PLANNING, ZONING, & BUILDING DEPARTMENT
PZ&B Staff Combination Memorandum: Architectural Commission and Town Council

SUBJECT: ARC-24-008 (ZON-24-047) 264 DUNBAR RD (COMBO)

MEETING: FEBRUARY 28, 2024, 2024 ARCOM
MARCH 13, 2024 TC

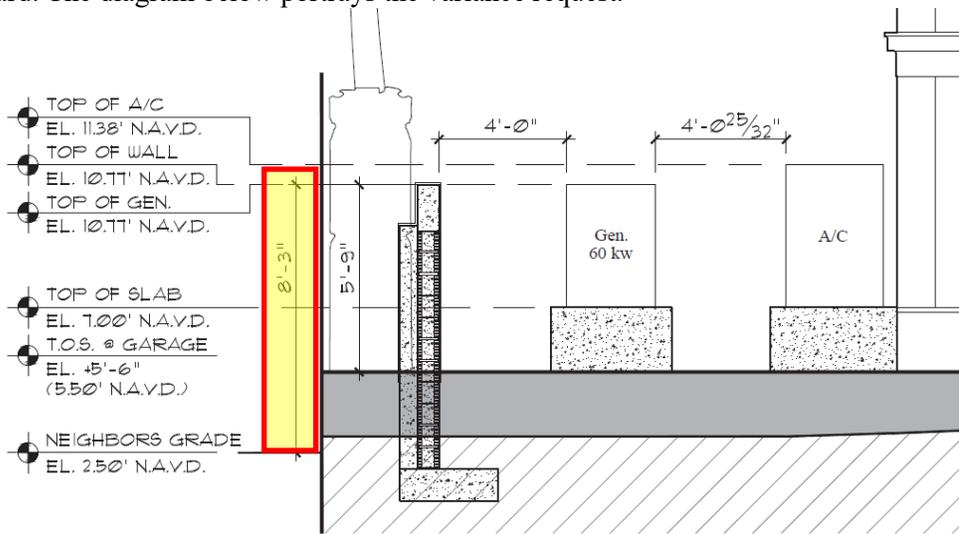
The application as presented requires (1) variance for construction; for the construction of an equipment screening site wall to exceed the maximum wall height permitted at the south equipment yard. The diagram below portrays the variance request.

Code Section	Required	Proposed	Variance
VARIANCE 1: Sec. 134-1669	Maximum Site Wall Height of 7'	Site Wall Height of 8.25' (for equipment screening)	1.25'
